PLANNING DIVISION STAFF REPORT

August 6, 2018

Project Name/Address: 104 E Gilman, Kendall House

Application Type: Certificate of Appropriateness for exterior alteration on a landmark site and in a historic district

Photo from the 1970s

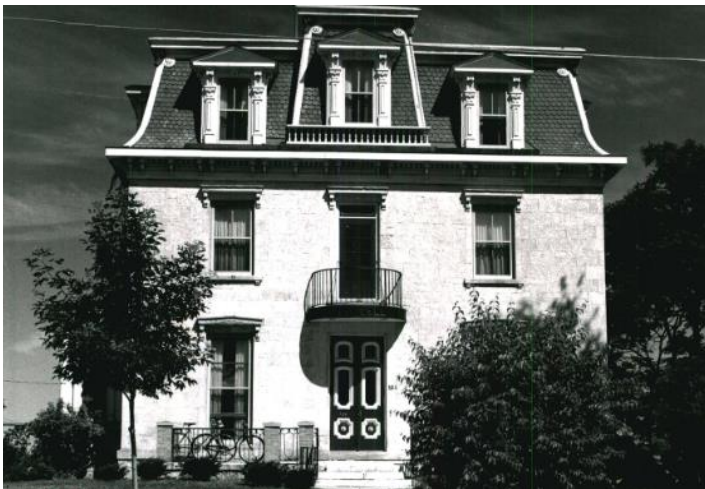
The work was constructed differently than approved. The piers were constructed in brick instead of wood and the brick was not in a color that was appropriate for the landmark building. The two middle piers flanking the front steps were constructed wider and taller than the other piers. In addition, the middle piers have been installed with conduit and wiring to receive a top mounted light fixture. Staff worked with the property owner's representative to find an agreeable solution to allow the brick piers to remain. The brick has been stained to closely match the color of the stone. In their current configuration, the piers are very similar to those shown in the photo from the 1970s except that the middle piers and the pier on the east corner are wider and taller than the other piers. There is ghost evidence on the building wall of an engaged pier on the east side of the porch.

Documentary evidence of the piers does not seem to be available so it is unknown if the original piers for the covered porch were brick or stone or wood. It may be possible that the piers shown in the photo from the 1970s are original to the construction of the covered porch. The original building did not have a mansard roof or a covered front porch as shown in the c. 1868 photo (WHi31861). The mansard roof is believed to have been added in 1873 and the porch may have been part of that same building campaign.

1. The caps of the piers that have been drilled for light fixtures shall be covered or replaced so that wiring cannot be accessed for the installation of light fixtures. It would be more appropriate to add light fixtures directed toward the stairs in a lower portion of the pier than to mount fixtures to the tops of the piers. Any light fixture installation would need the review and approval of the Landmarks Commission. If the caps are replaced, they should have a pyramidal sloped top surface instead of being flat. In addition, the overhang should be reduced so that the cap is more appropriately sized to the pier.

2. The middle piers shall be reduced in height so that they match the height of the other piers.
3. The east corner pier should be reduced in height and width so that it matches the height and width of the other piers. The cap should be made smaller so that the overhang matches the overhang of the other piers.

4. An engaged pier shall be constructed to match the existing engaged pier on the opposite side.
5. The Applicant shall provide more information about the previously installed metal railings that are proposed to be reinstalled for Commission review.
